ADDENDUM 1 DATE: February 11, 2019

Contract 18-C-00036; Madison Street Park

Bidders on the above referenced project are hereby notified that the following addendum is made to the Contract Documents. BIDS TO BE SUBMITTED SHALL CONFORM TO THIS NOTICE.

Drawing No. L523

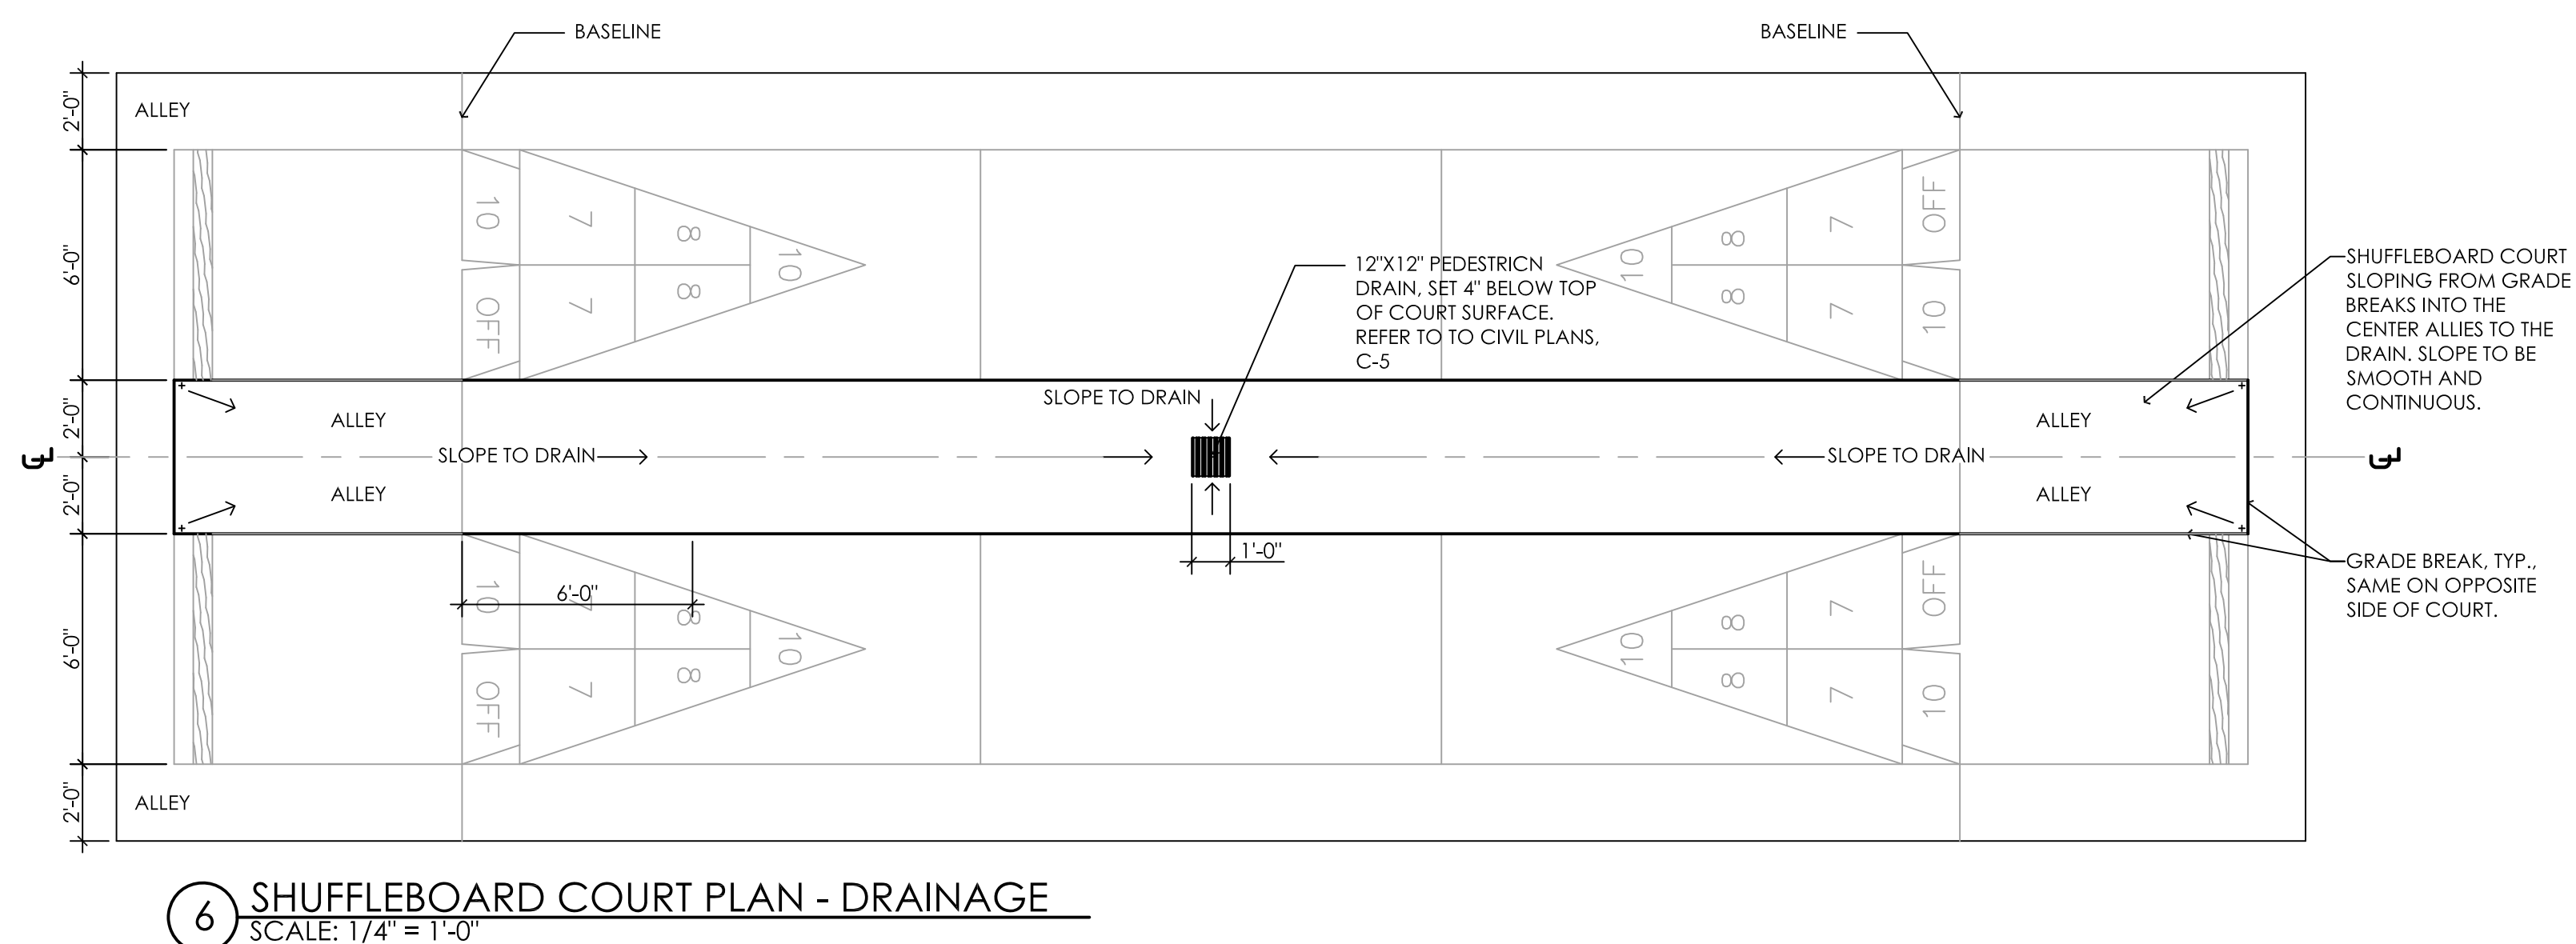
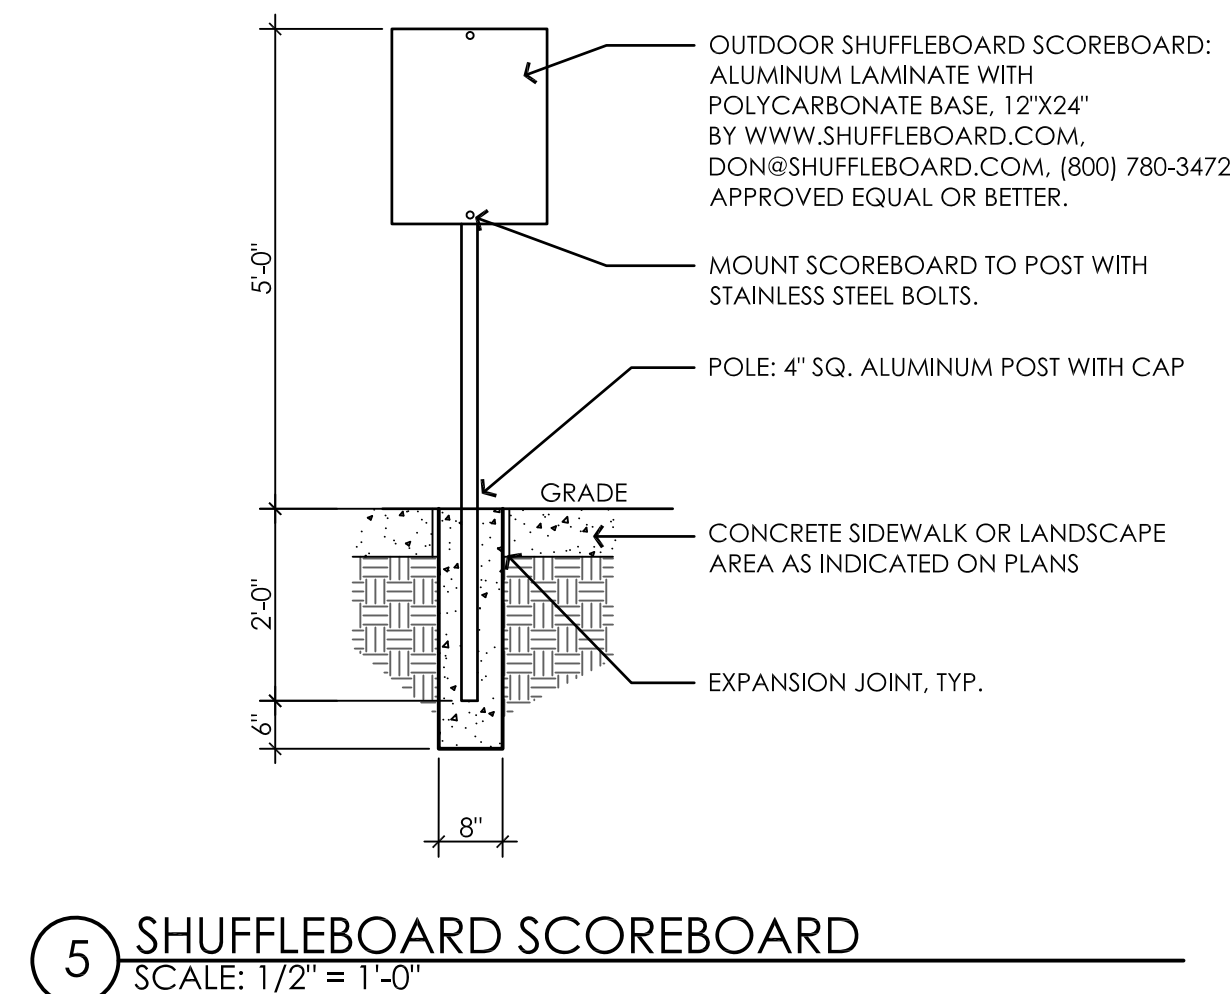
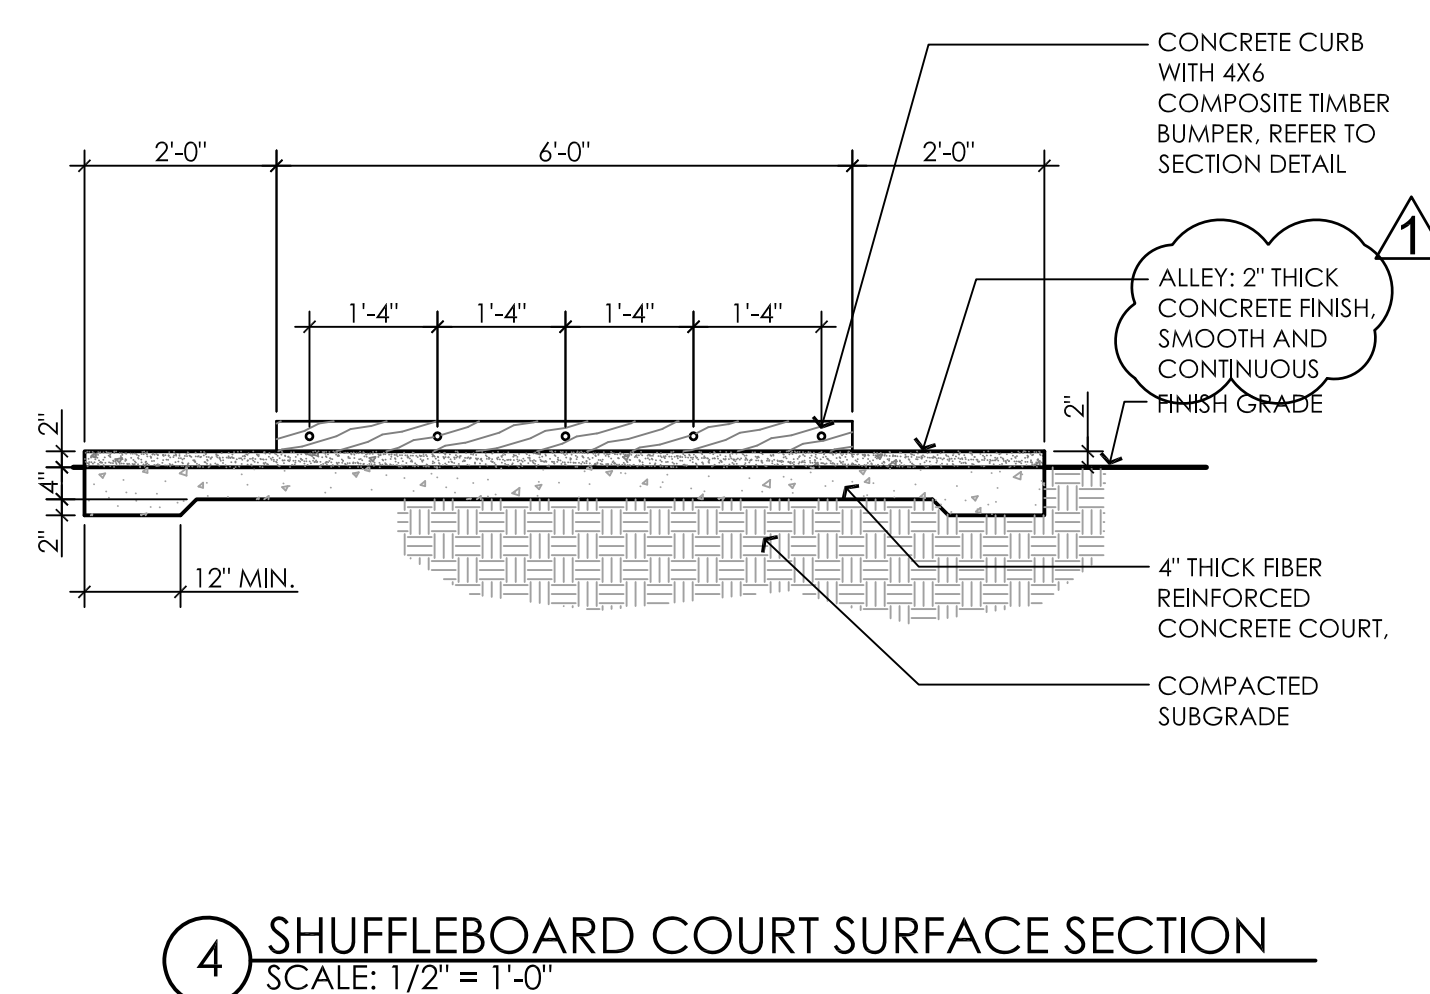
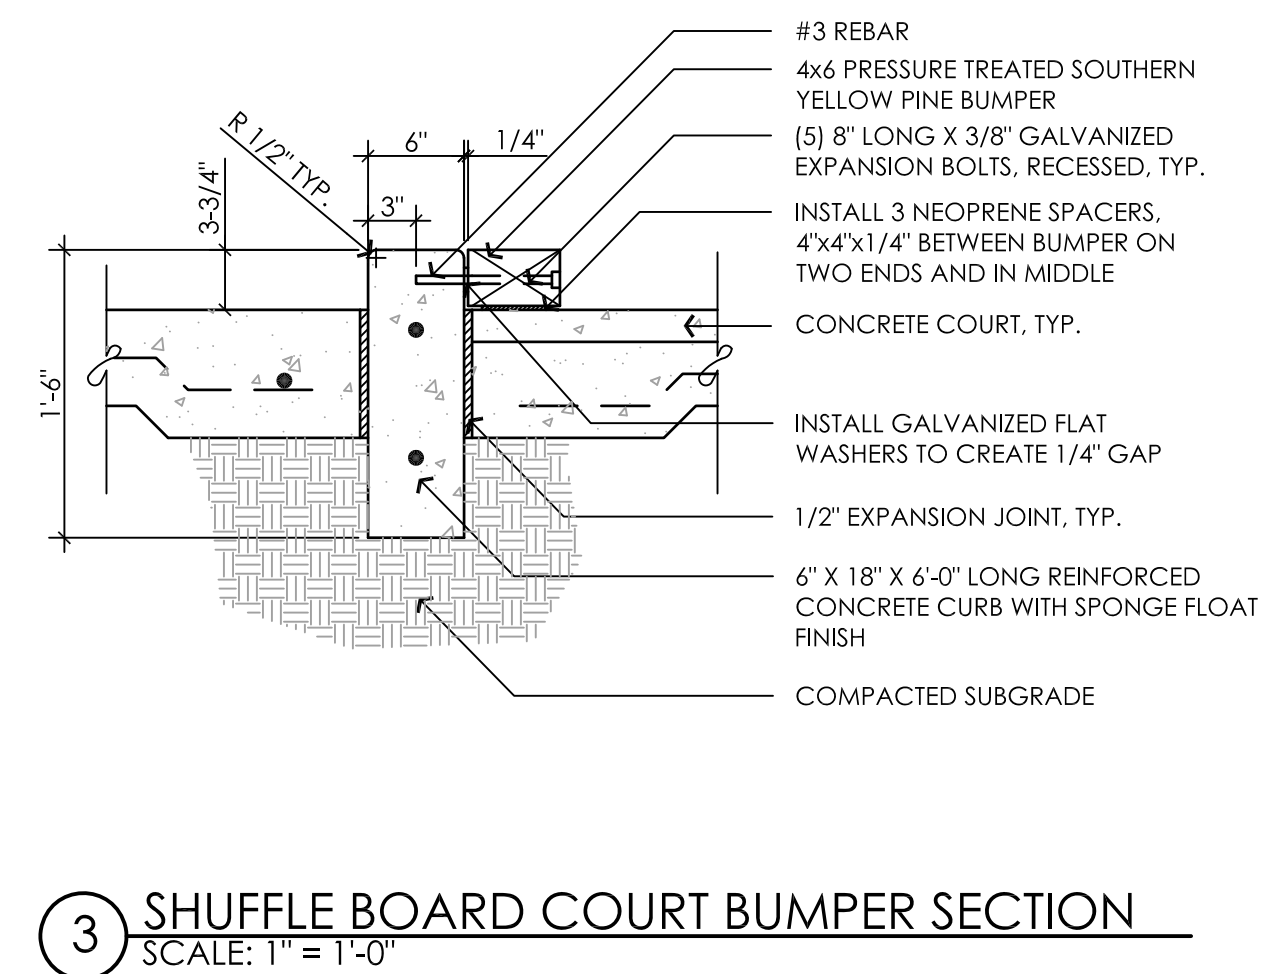
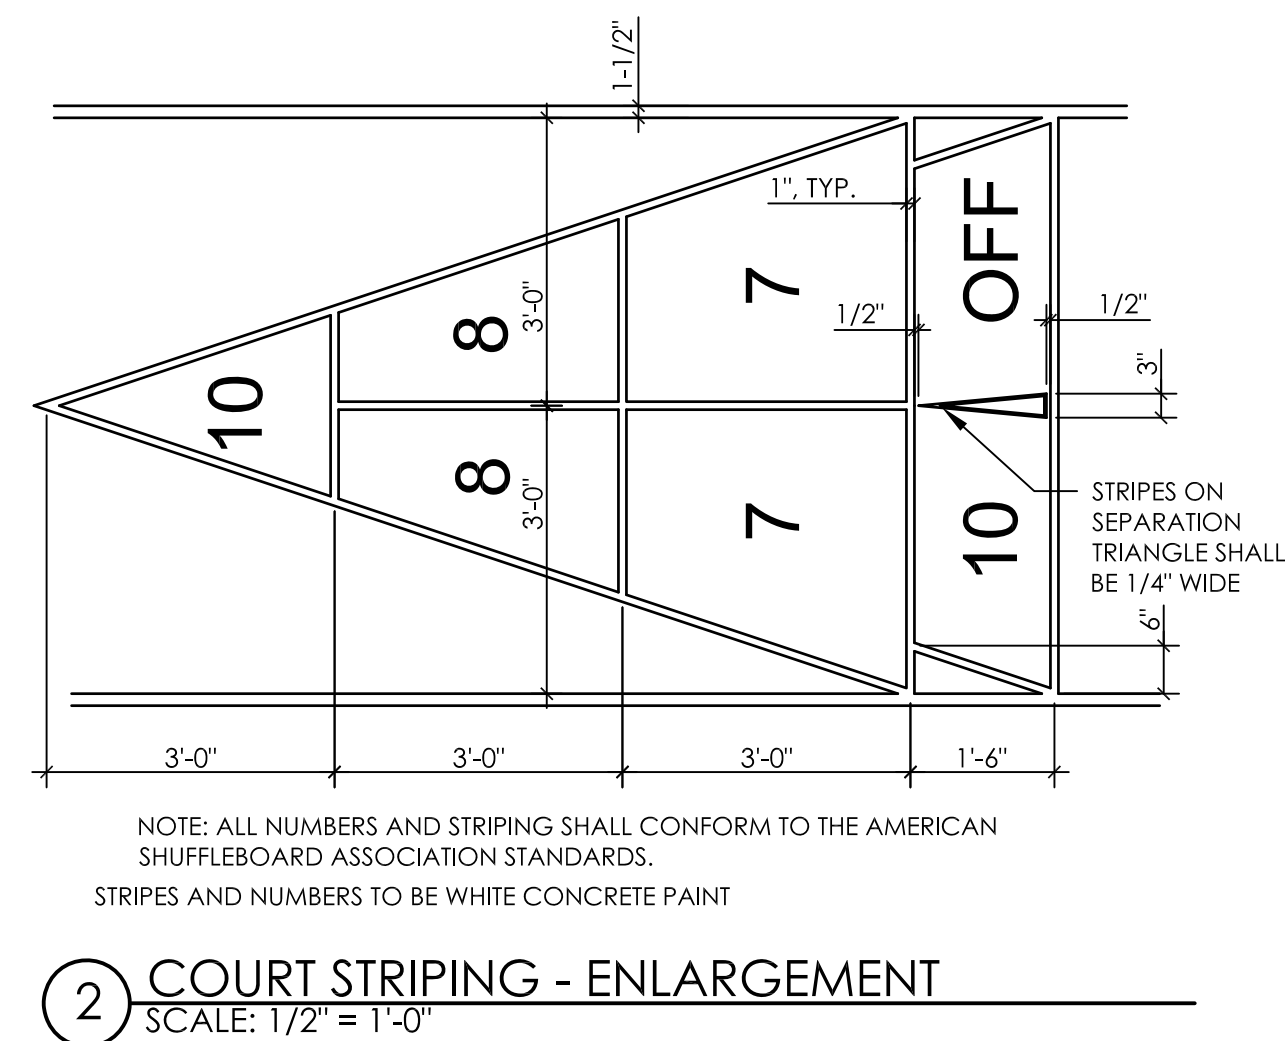
- Item 4: Replace plan Sheet L120 with the attached Sheet L120.
- Item 5: Replace plan Sheet L523 with attached Sheet L523.
- Item 6: Clarification: plan Sheet L522 Hardscape Details, Detail 8 Seat Wall Section: The 4"x4" tiles are to be supplied and installed by the Contractor. Tile detail will be specified by artist, coordinated through the City and payment made under contract pay item no. 9002 Public Art Allowance.
